UNITED STATES PATENT AND TRADEMARK OFFICE

APPLICATION NO.	FILING DATE	FIRST NAMED INVENTOR	ATTORNEY DOCKET NO.	CONFIRMATION NO.
10/779,393	02/13/2004	Harumi Ooshima	10445/13	9011

Office Action Summary

DETAILED ACTION

Below is an enlarged section of figure 3:

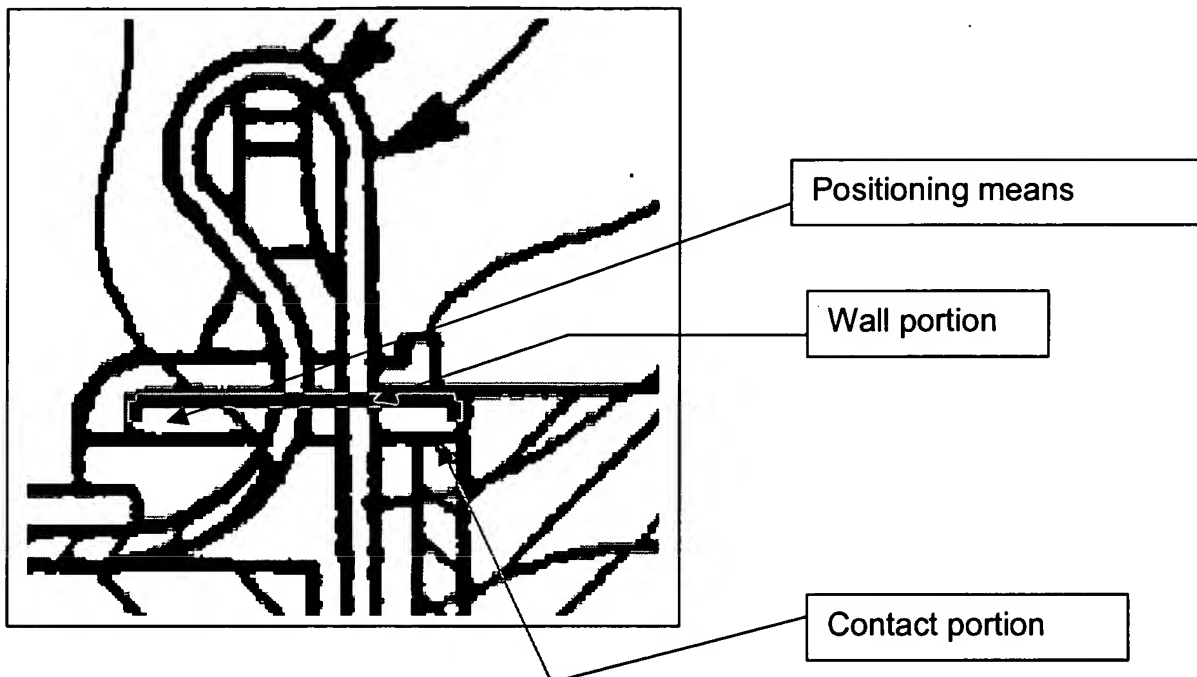
Re: claims 2, 8, and 9. Kobayashi et al. show in figures 1, 3, and 4 the limitation wherein the positioning means restrict movement of the distal end portion of the return spring by means of a wall portion (including the upper surface and side surfaces of the portion shown directly below element 13A) formed on (left surface of) the supporting member as labeled on pg. 8.

Re: claims 3, 4, 10, and 11. Kobayashi et al. show in figures 1, 3, and 4 the limitation wherein a guiding member 12 is interposed between the brake pads and the supporting member, the guiding member comprises a contact portion as labeled on pg. 8 which extends to the vicinity of the wall portion along the surface of the supporting

Re: claims 5, 6, 12, and 13. Kobayashi et al. show in figures 1, 3, and 4 the limitation wherein a guiding member 12 is interposed between the brake pads and the supporting member, and the positioning means or portion shown directly below element 13A restrict movement of the distal end portion of the return spring by means of a wall portion (particularly the left side surface of the wall portion) formed on the (upper surface of the) guiding member.
